Access Compliance Report

Public Rights-of-Way

Intersection ID: 28215	Main Street: ARDREY_KELL_RD	Cross Street: LANDING_GREEN_DR	Location: SE
ADA ID: DE76EDFFB0C1	Ramp Type: PerpDiag	Initial Pass/Fail: Fail	Overall Compliance: No
		Severity Score: 25

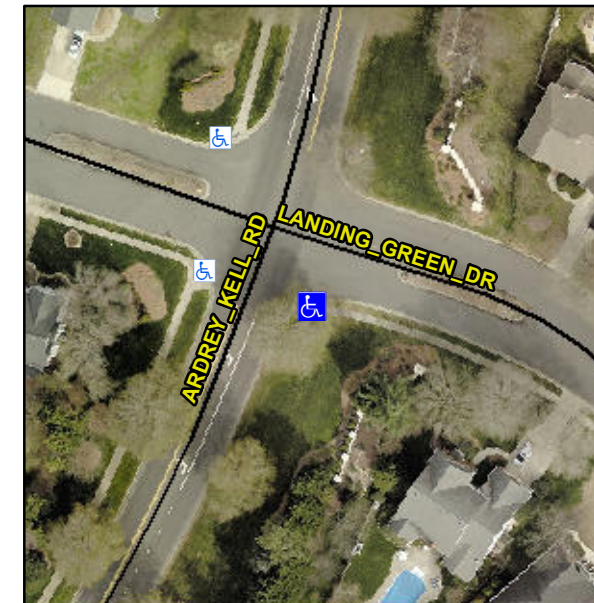
R304.2.2, R304.5.3

Compliance	Description	Data	Compliance	Description	Data
N/A	Ramp Length (in)	95.5	No	Ramp Slope (%)	10.2
Yes	Ramp Width (in)	58.0	No	Ramp XSlope (%)	6.3
N/A	Flare Type LT	N/A	N/A	Flare Type RT	N/A
N/A	Flare Slope LT (%)	N/A	N/A	Flare Slope RT (%)	N/A
N/A	Flare Traversable LT?	N/A	N/A	Flare Traversable RT?	N/A
N/A	Landing Length (in)	N/A	N/A	DWS Provided?	N/A
N/A	Landing Width (in)	N/A	N/A	DWS Contrast?	N/A
N/A	Landing Slope (%)	N/A	N/A	DWS Length (in)	N/A
N/A	Landing X Slope (%)	N/A	N/A	DWS Full Width?	N/A
N/A	Landing Curb? (Y/N)	N/A	N/A	DWS Offset (in)	N/A
N/A	Shared Landing?	N/A			
N/A	Gutter Ponding?	N/A	N/A	Gutter Slope (%)	N/A
N/A	Gutter Lip Ht (in)	1.0	N/A	Gutter X Slope (%)	N/A
N/A	Painted X Walk1?	No	N/A	Painted X Walk2?	No
	X Walk 1 Direction	To NE		X Walk 2 Direction	To NW
N/A	X Walk 1 Width (in)	N/A	N/A	X Walk 2 Width (in)	N/A
	X Walk 1 Slope (%)	2.9		X Walk 2 Slope (%)	3.1
	X Walk 1 X Slope (%)	3.1		X Walk 2 X Slope (%)	3.3

Remove & Replace Curb Ramp With Two New Directional Ramps or Equivalent.
